"ADDITIONAL INFORMATION"

RFI Ref: SD21A/0229

Retention for 2 bay portal frame, additional floor area to existing industrial unit. Permission for roofing of 2 bay portal frame structure; extension to existing industrial unit; construction of a concrete resurfaced area in main yard; minor internal layout and elevational revisions to existing industrial unit and all associated site works including underground surface water attenuation and related utilities and works.

At Heiton Steel, Ashfield, Naas Road, Clondalkin, Dublin

Item 4

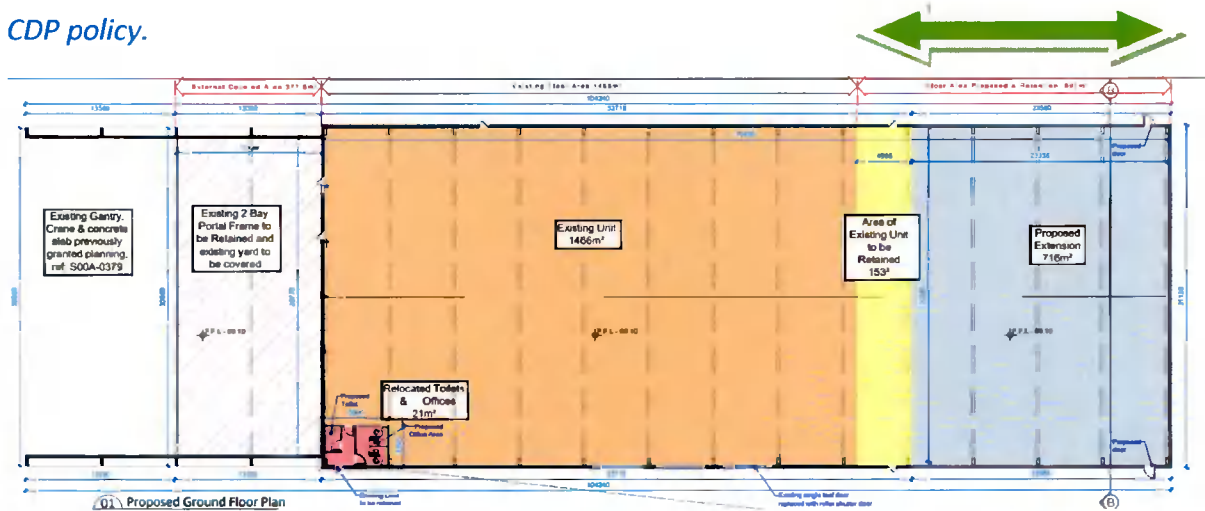
4. Section 11.2.1 Design Statements of the CDP requires developments over 1,000sq.m to be accompanied by a Design Statement consisting of a site analysis, a concept plan and/or masterplan, a statement based on the design criteria listed in Section 11.2.0 and/or tables 11.17 and 11.18 and a statement or Quality Audit addressing street design as outlined within the Design Manual for Urban Roads and Streets. The proposal is split into a number of elements. The applicant states on their application form that the following floor area would be created:

The applicant is requested to clarify the level of floorspace created by the proposal. Should the total floorspace be greater than 1,000sq.m, then a design statement should be provided in accordance with

Please note as follows that the total area of floorspace being retained & extended is 869m² as follows :

Area of existing building to be retained 153 m² (yellow)

Proposed extension 716 m² (blue)

The total level of floorspace in the proposal 869 m². See above

- The 2bay portal area being retained is covered only and no floorspace is provided.
- Note that as the additional floorspace proposed in this application is less than 1000m² then a Design Statement is not required.

Detail of proposed Swail

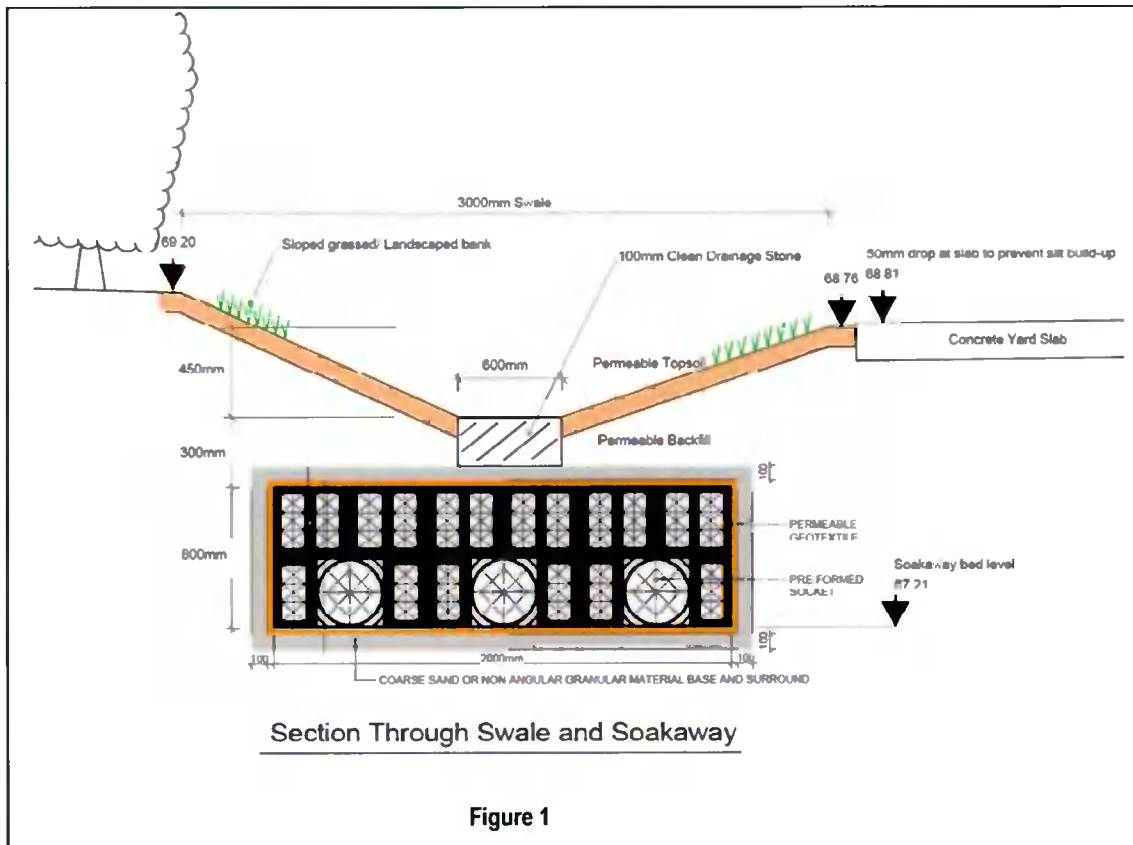
6. The proposed development of a significantly large site, with sizeable structures and substantial roof coverage, resurfacing and hard engineering solutions to manage surface water drainage, all in close proximity to open space and at a location with minimal green infrastructure, where no green infrastructural elements are proposed, the applicant is requested to submit:

(1) Increased measures to mitigate the immense impact of the proposed development on the area and the environment such as green walls, green roofs, planted swales amongst other Green Infrastructure items.

(2) Proposals to augment linkages between the open space and new ecological areas proposed within the site (open attenuation areas and other planted areas), as well as augmenting links through the site to connect to other ecological corridors. These items would help to strengthen the viability of green pathways through the county and creating wider ecological corridors and linkages; would contribute to a healthier environment for workers on the site as well as deliver climate actions leading to Climate Adaptation and thereby meeting national guidance and targets. To lessen the impact of this disturbance the applicant is requested to submit mitigating proposals within an ecological report and landscaping plan. Proposals and mitigating solutions should include the greening of all infrastructural elements of the design.

See enclosed mitigation measures such as proposed Swail, permeable paving and the applicants commitment to landscaping for pollination and all within an existing commercial / industrial yard setting. Full details in enclosed documentation and reports.

There are limitations to the commercial and storage use of the existing site which for Health & Safety and logistical reasons prevent green links and or corridors within the site. However the proposed Swail along the boundary is a significant step towards a sustainable and ecological integration of the site and its surroundings.

3.1 SUDS Measures

- Provision of 3m wide Swale with a Soakaway along the southern boundary of the site. The developer is involved in the All Ireland Pollinator Plan which encourages the provision of green and planted areas for bees. This swale can be planted with suitable native grasses in line with this Plan.
- The new concrete yard slab is to connect to the proposed Swale.
- The new extension roof is a pitched roof to match the existing roof, because of this a Green Roof drainage solution is not suitable. We propose to connect the roof drainage to the Swale.
- The footpath at the side of the building is proposed as Permeable Paving.
